**IOWA DEPARTMENT OF NATURAL RESOURCES
ADDENDUM No. 1
LAND & WATERS BUREAU**

VIKING LAKE STATE PARK
WASTE WATER SYSTEM UPGRADE
MONTGOMERY COUNTY, IOWA
PROJECT NUMBER: 19-04-69-02

May 15, 2019

FRONT VIEW - PANEL STATION

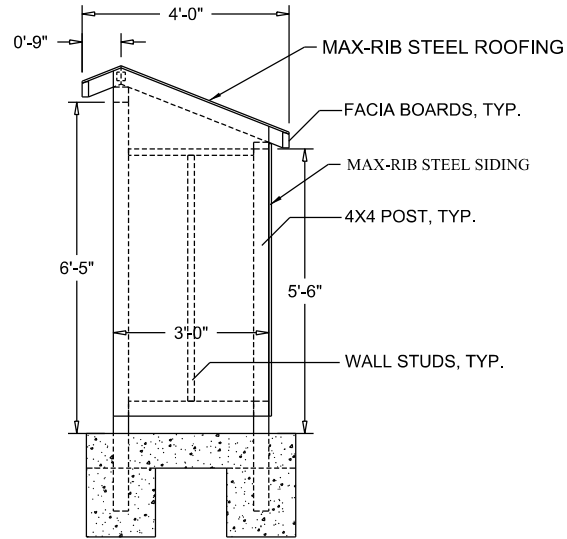
1. The controls for the packed bed filter shall be installed in a covered structure shown in the drawings below. The cost of the control structure shall be part of item No. 6 in Estimated Project Quantities on sheet 7 of the plans.

1. MCELROY MAX-RIB SIDING, COLOR TO BE TERRA TONE. TRIM CORNERS AND EDGES WITH APPROPRIATE TRIM BY MANUFACTURER.
2. PRESSURE TREATED 4X4 POSTS, EMBED POSTS INTO CONCRETE AS SHOWN.
3. 5/8" ROOF SHEATHING WITH WATER AND ICE SEILD OVER ENTIRE ROOF STRUCTURE. INSTALL MCELROY MAX-RIB ROOFING, COLOR TO BE DARK BRONZE. TRIM ALL EDGES OF ROOFIG PER MANUFACTURER'S RECOMMENDATIONS.
4. 1X4 TREATED FASCIA
